Access Compliance Report Public Rights-of-Way (Curb Ramps)

Intersection ID: 5464 Main Street: OAK_DR Cross Street: WANAMASSA_DR Location: **Overall Compliance: No ADA ID: FEE50D2118E7** Ramp Type: Perp Initial Pass/Fail: Fail Severity Score: 21.25

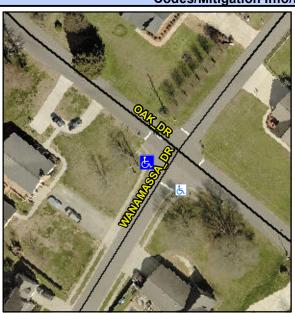
Possible Solutions: Remove & Replace Entire Ramp. Surveyor Notes: N/A PROW/ADA: Not Found, R304.5.1, R304.2.2

Field Measurements/Component Compliance					
Compliance Description		Data	Comp	liance Description	Data
N/A	Ramp Length (in)	47.0	No	Ramp Slope (%)	9.7
No	Ramp Width (in)	45.0	Yes	Ramp XSlope (%)	0.1
N/A	Flare Type LT	N/A	N/A	Flare Type RT	N/A
N/A	Flare Slope LT (%)	N/A	N/A	Flare Slope RT (%)	N/A
N/A	Flare Traversable LT?	N/A	N/A	Flare Traversable RT?	N/A
N/A	Landing Length (in)	N/A	N/A	DWS Provided?	N/A
N/A	Landing Width (in)	N/A	N/A	DWS Contrast?	N/A
N/A	Landing Slope (%)	N/A	N/A	DWS Length (in)	N/A
N/A	Landing X Slope (%)	N/A	N/A	DWS Full Width?	N/A
N/A	Landing Curb? (Y/N)	N/A	N/A	DWS Offset (in)	N/A
N/A	Shared Landing?	N/A			
N/A	Gutter Ponding?	N/A	N/A	Gutter Slope (%)	N/A
N/A	Gutter Lip Ht (in)	N/A	N/A	Gutter X Slope (%)	N/A
N/A	Painted X Walk1?	No	N/A	Painted X Walk2?	N/A
	X Walk 1 Direction	To S		X Walk 2 Direction	N/A
N/A	X Walk 1 Width (in)	N/A	N/A	X Walk 2 Width (in)	N/A
	X Walk 1 Slope (%)	8.6		X Walk 2 Slope (%)	N/A
